## Slow Trim/Tilt Rate - 1992 75 thru 115

This is a revision of Outboard Service Bulletin 92-8. Destroy Bulletin 92-8 and insert Bulletin 92-8A. Revision is due to the change in the availability of P/N 811670 and 811670--1. Changes are underlined>.

Single Ram Power Trim  
with Date Code 11310 and Earlier

**Figure 1. Single Ram Power Trim**

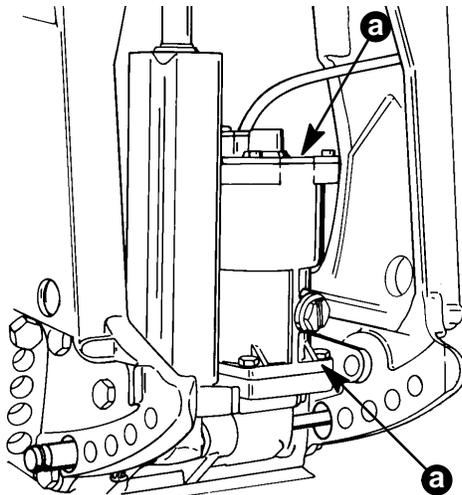
Some single ram power trim units with date code 11310 and earlier may trim/tilt at a slower rate than designed. Refer to INSPECTION following to determine if the power trim unit is slower. Newer units with date code 11311 and later have recessed check valves to correct the slow trim/tilt rate.

a - Date Code Locations

**Figure 2. Bottom View of Pump/Manifold**

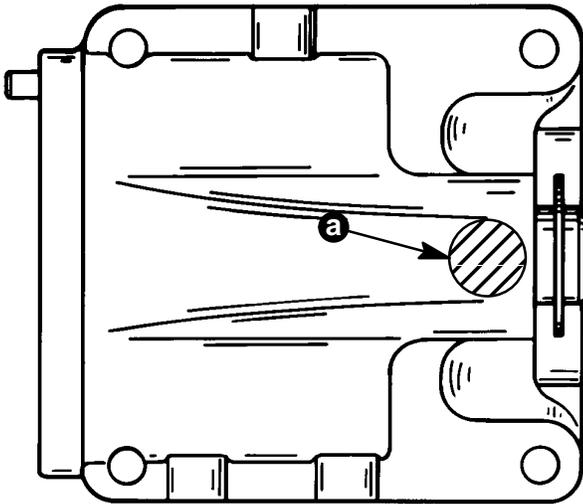
Replace pump/manifold using one of three improved service replacement assemblies. Pump/manifolds P/N 811670 with improved check valves are identified by a white dot on the bottom on the manifold. Pump manifolds P/N 811670--1 and 811670--2 have the check valve improvement and are identified by a green paint mark on the top of the manifold next to the trim/tilt cylinder mating surface as well as the white dot on the bottom of the manifold.

a - Location of White Dot.

P/N 811670 - Pump/Manifold which is NLA  
White paint dot on the bottom

P/N 811670--1 - Pump/Manifold which is NLA  
White paint dot on the bottom  
Green paint mark on the top

P/N 811670--2 - Pump/Manifold with pilot relief valve  
White paint dot on the bottom  
Green paint mark on the top
